# HISTORIC AND DESIGN REVIEW COMMISSION

**HDRC CASE NO:** 2020-308  
**ADDRESS:** 931 HAYS ST  
**LEGAL DESCRIPTION:** NCB 1654 BLK B LOT S 140 FT OF 16  
**ZONING:** R-5, H  
**CITY COUNCIL DIST.:** 2  
**DISTRICT:** Dignowity Hill Historic District  
**APPLICANT:** ADAM SANCHEZ/CENTER CITY HOMES, LLC  
**OWNER:** Alan & Faith Johnson/LOWRY ALAN J & JOHNSON FAITH E  
**TYPE OF WORK:** Installation of wood window screens  
**APPLICATION RECEIVED:** June 25, 2020  
**60-DAY REVIEW:** Not applicable due to City Council Emergency Orders  
**CASE MANAGER:** Edward Hall

## REQUEST:

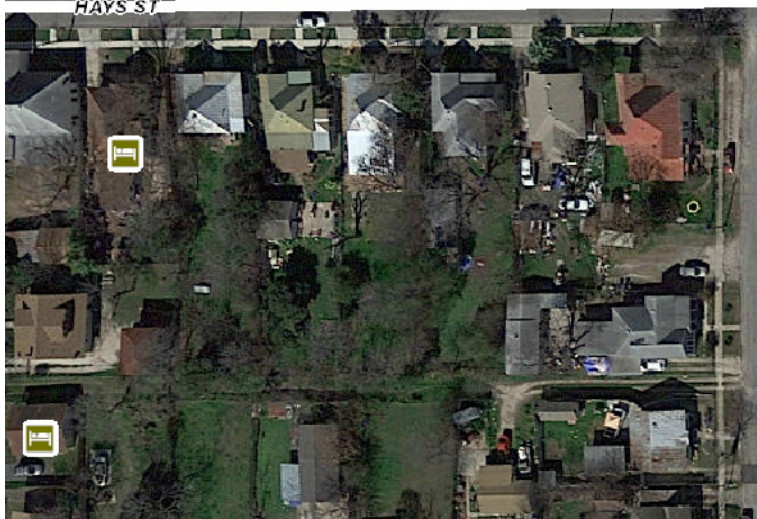
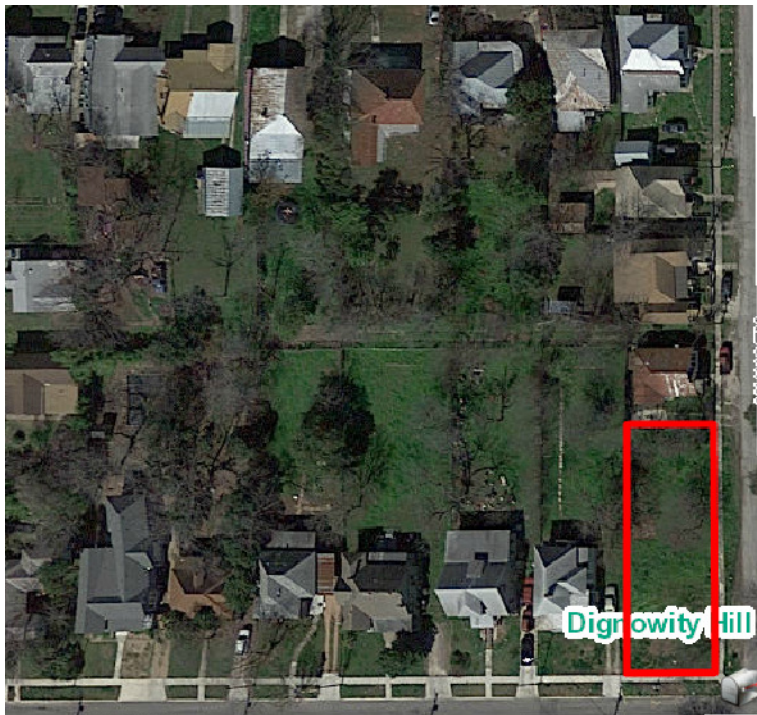
- b. DESIGN REVIEW COMMITTEE – The applicant constructed a mockup that was reviewed by staff at a site visit. The proposed mockup was subsequently commented on by the Design Review Committee who commented that while the window screens may be appropriate in style and profile, they did not find the proposed screens to be an adequate solution to the vinyl windows, which were previously denied by the Commission as noted in finding a.
- c. WINDOW SCREENS – As noted in finding a, the applicant has proposed to install window screens at 931 Hays to cover the installed vinyl windows. While the installation of window screens may be appropriate in new construction, staff does not find the proposed window screens to be an appropriate solution to the installed vinyl windows.

Staff does not recommend approval based on findings a through c. Staff recommends that the applicant install windows that are consistent with those that were originally approved, aluminum clad wood windows, rather than install a wood window screen to cover the previously denied vinyl windows.
